***Interactive comment on* “Evaluation of soil moisture downscaling using a simple thermal based proxy – the REMEDHUS network (Spain) example” by J. Peng et al.**

N. Sánchez (Referee)

Received and published: 25 September 2015

Fig. 1.

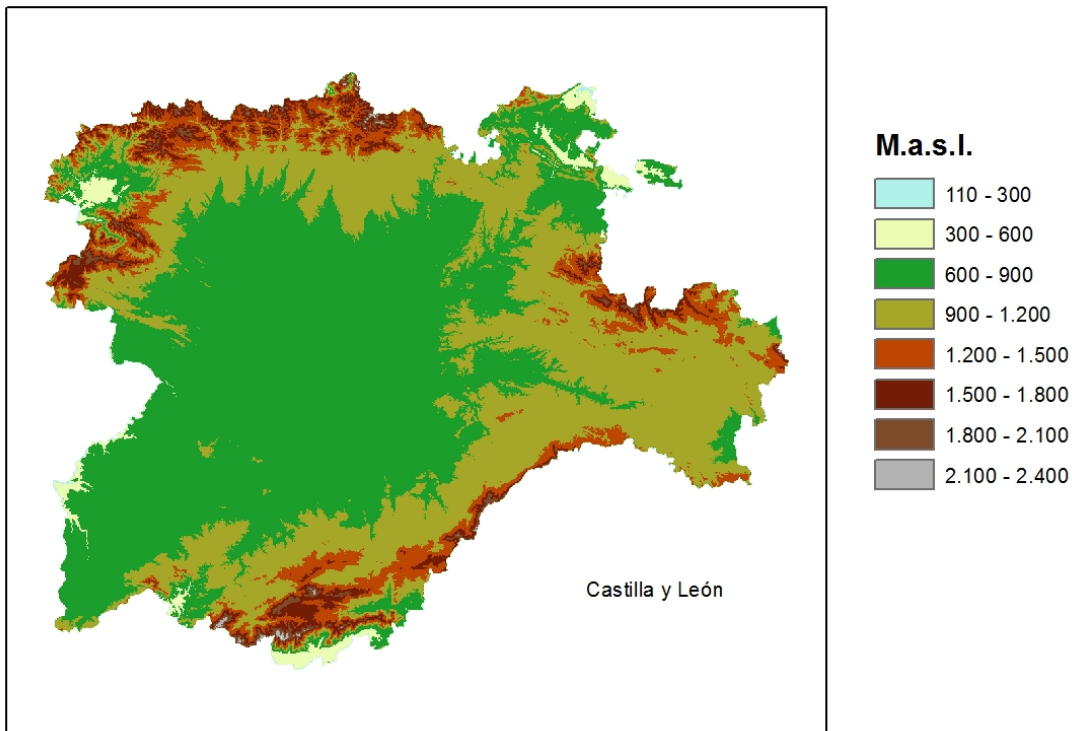
- The study of the topography seemed contradictory to me with the downscaling approach, and wrongly focused. First, since the area of study is selected, among other reasons, based on its flatness (lines 12–13 p.8510, according to the Triangle method assumption), I do not see how the topography would be worth considering. Second, you chose a criterion based on ‘removing the areas with 300 m higher or lower elevation than the average REMEDHUS elevation’. Given the REMEDHUS average of 777 m, there are almost no areas below the range you chose, and only a few beyond. I enclose the Figure 1 to illustrate this reasoning. Thus, the poor influence of the topography showed in the sensitivity analysis is not surprising, as you recognize on p.8520 and in Figure 5.

Figure 1. Digital Elevation Model of Castilla y León
